**Item No. 11.1**  
**Halifax Regional Council**  
**February 16, 2016**

**SUBJECT:** **Case 20227: Appeal of the Design Review Committee's Approval of the Substantive Site Plan Application for the Margareta Development at 1447 Dresden Row, Halifax**

**SUBJECT:** **Case 20227: Substantive Site Plan Approval – Mixed-use Development at  
1447 Dresden Row, Halifax**

**South - Clyde Street Elevation**

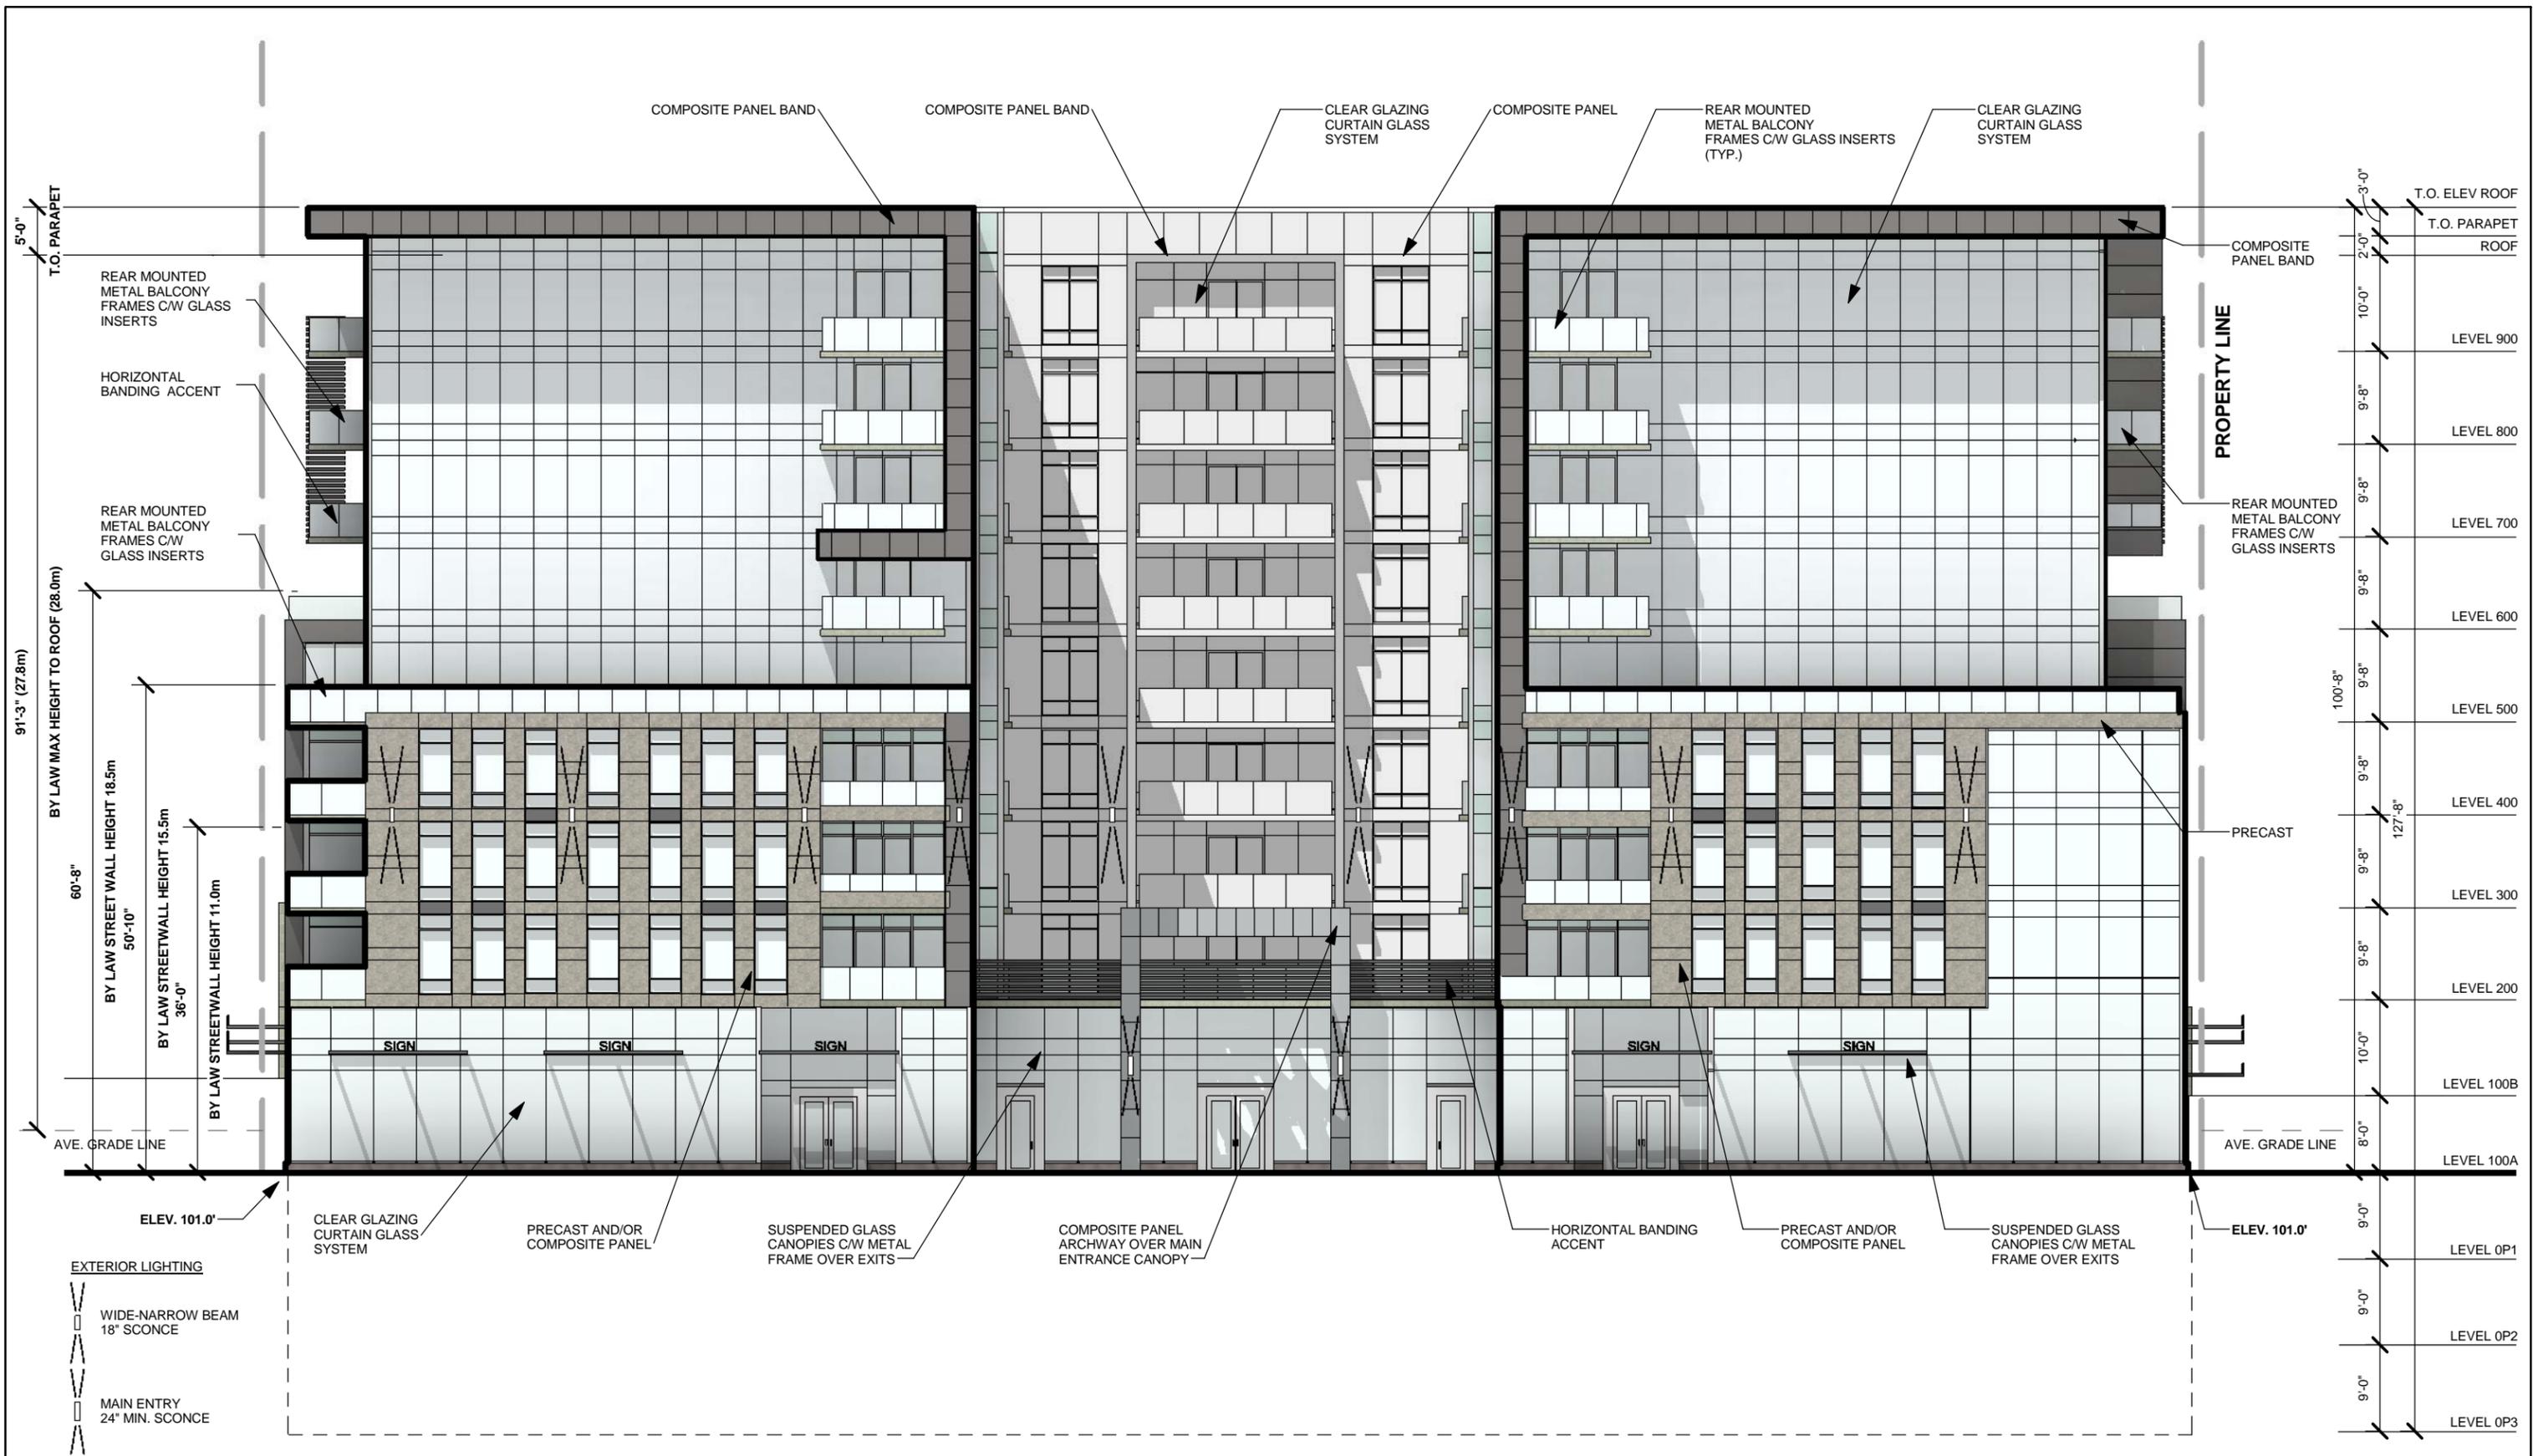
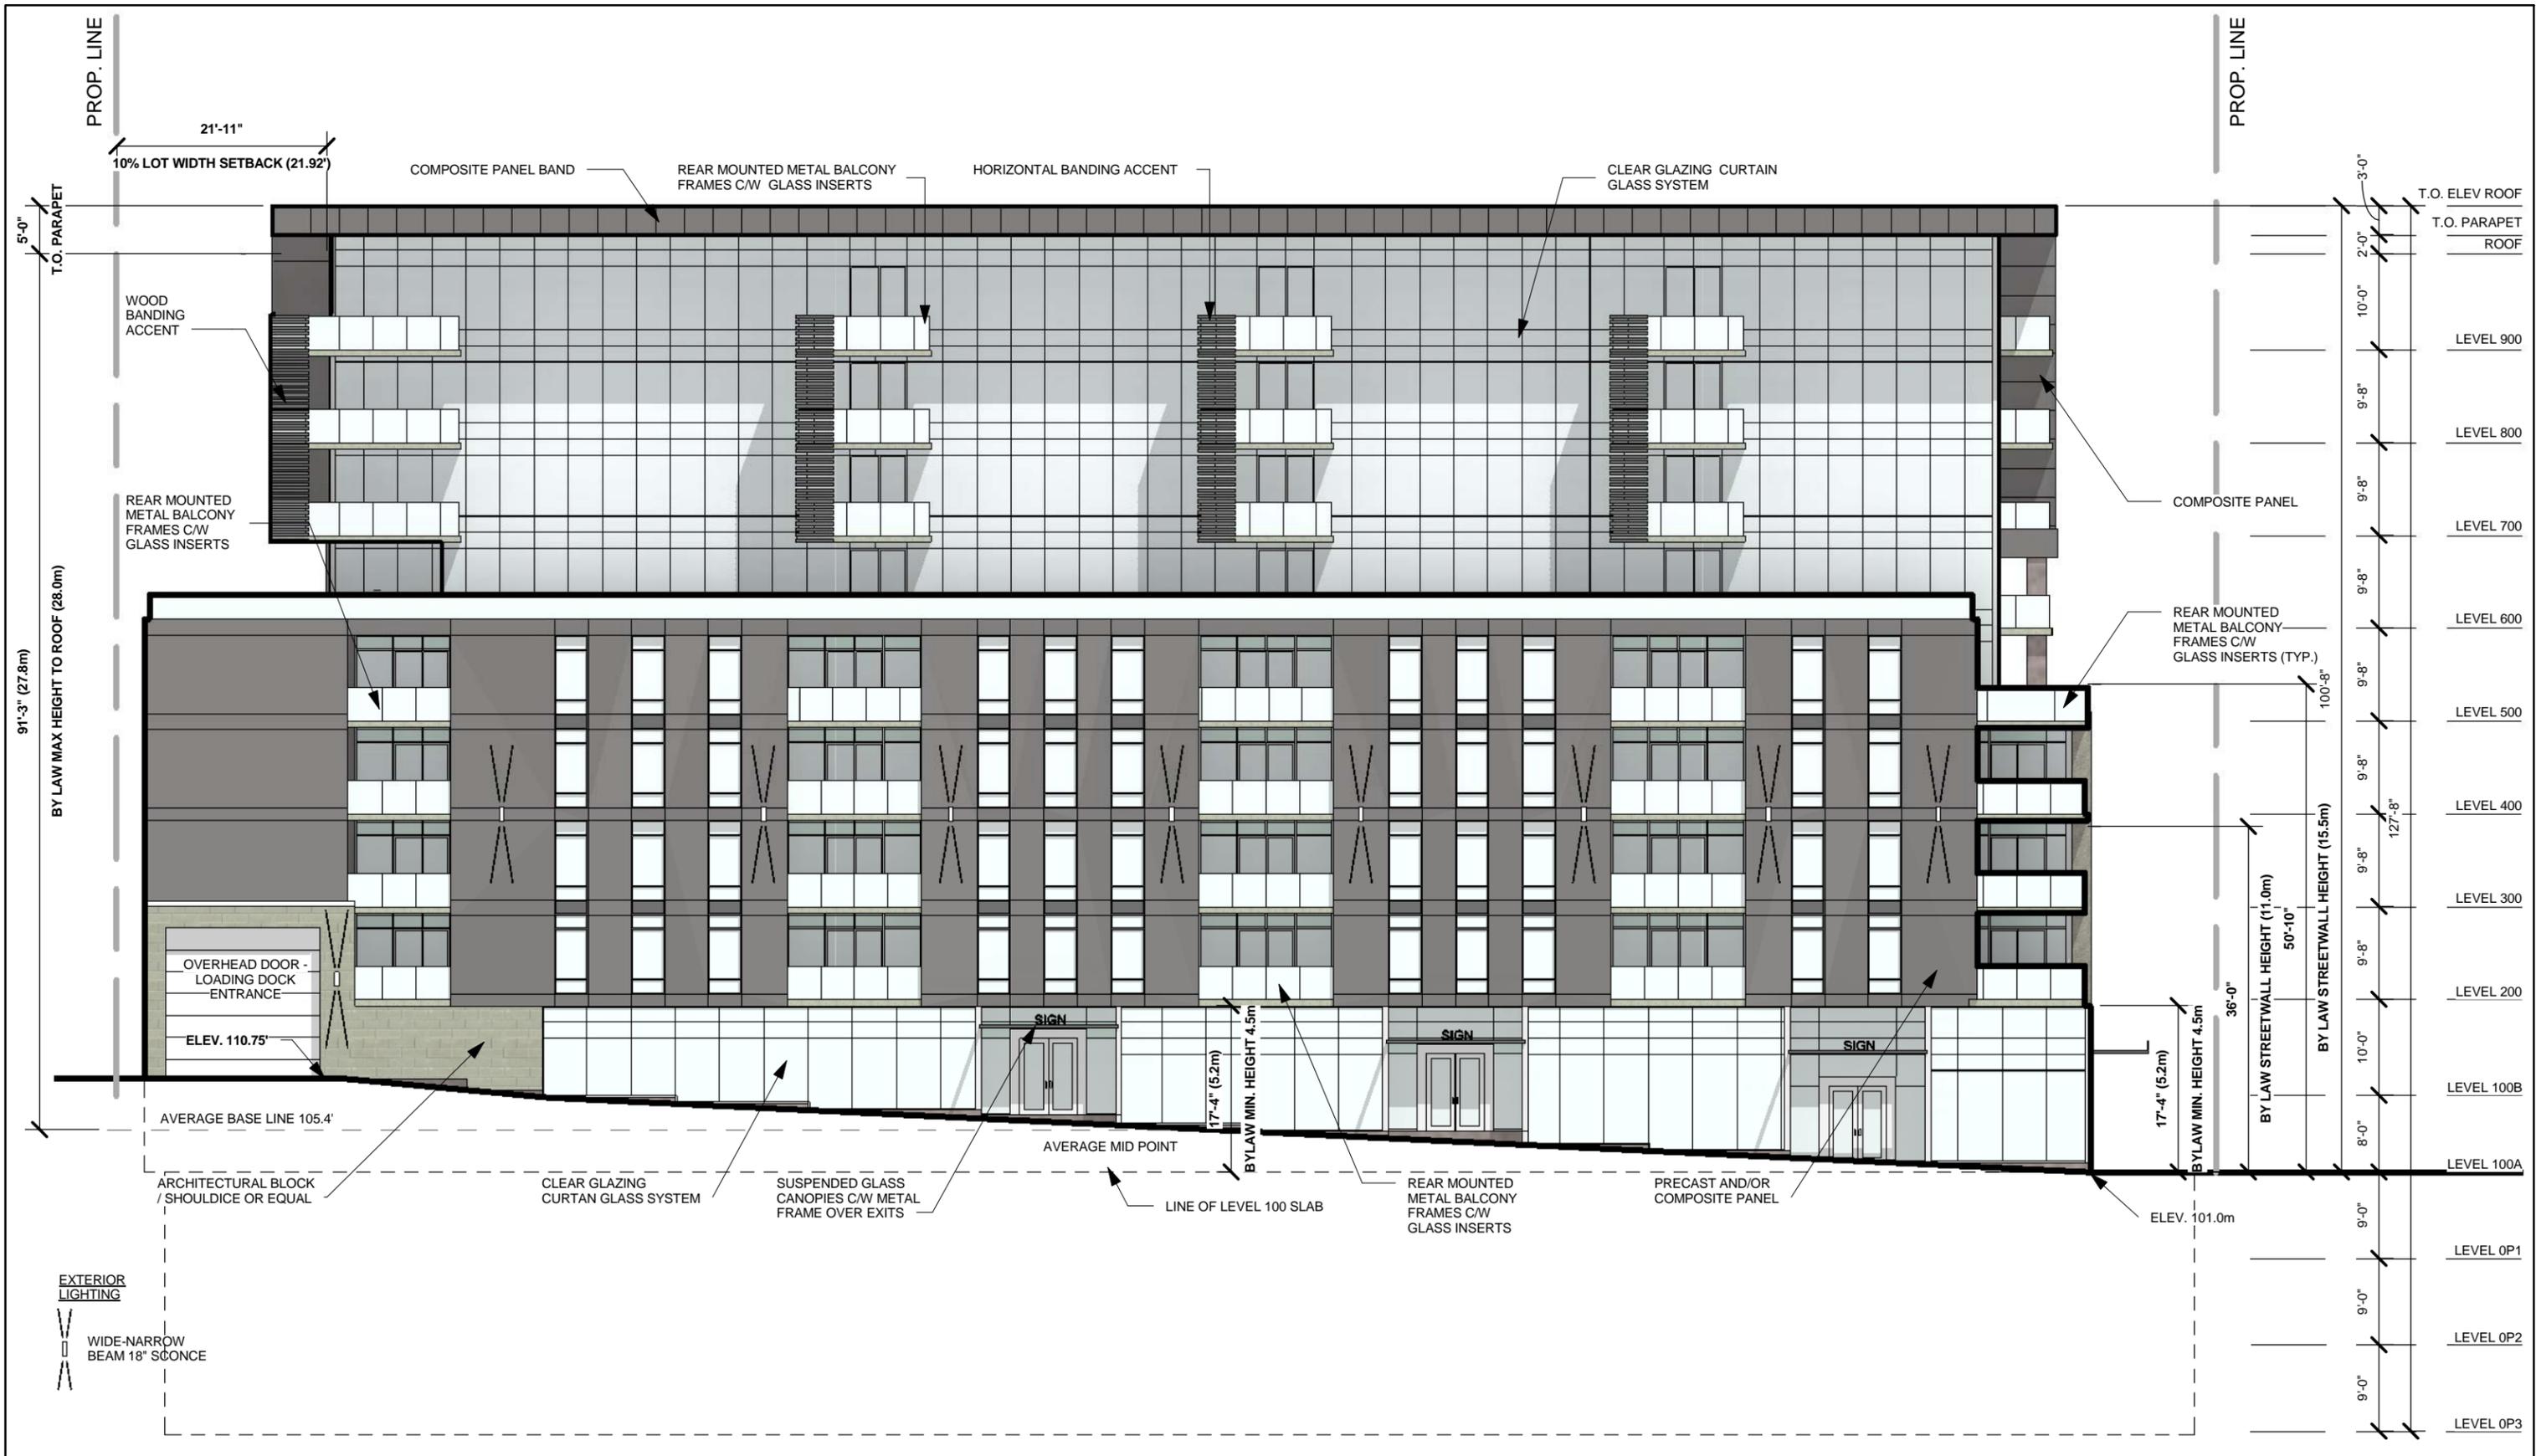
*Appellants' Rationale: "... the building plans discuss the pedestrianization of Clyde St. and the Margarettta being landscaped with permeant sidewalk benches. We are opposed to these benches on grounds of security and sidewalk traffic flow. In a recent poll done for the Heritage Conservation District for Schmidville showed that benches are not desired. In regards to security it is to be noted that on numerous occasions both homeowners have found beer bottles and other items left outside their doorstep. Permanent benches will only encourage negative activity in the evening and block a clear path for disabled pedestrians."*

was merely an artist's rendering error or does it have other implications? Furthermore, the building plans discuss the pedestrianization of Clyde St. and the Margareta being landscaped with permeant sidewalk benches. We are opposed to these benches on grounds of security and sidewalk traffic flow. In a recent poll done for the Heritage Conservation District for Schmidville showed that benches are not desired. In regards to security it is to be noted that on numerous occasions both homeowners have found beer bottles and other items left outside their doorstep. Permanent benches will only encourage negative activity in the evening and block a clear path for disabled pedestrians.

*Staff's Response:* While Clyde Street is not a designated "Pedestrian-Oriented Commercial Street", the Design Manual calls for it to evolve into an important pedestrian street. This is advanced through the project by the implementation of a 4-metre setback requirement under the LUB, and the installation of landscaping and permanent benches along Clyde Street. Such improvements serve to create an active and engaging pedestrian experience along the street, and enhance the streetscape design. They also promote linkage between the Central Library and Victoria Park.

Council should note that the matter relating to the 4-metre streetwall setbacks along Clyde Street is a LUB requirement that was reviewed and determined to be in compliance with the LUB by the Development Officer. As such, it is not a matter for which Regional Council can consider under the site plan appeal process. However, the elements of landscaping and the placement of permanent benches along Clyde Street are before Regional Council for a decision.
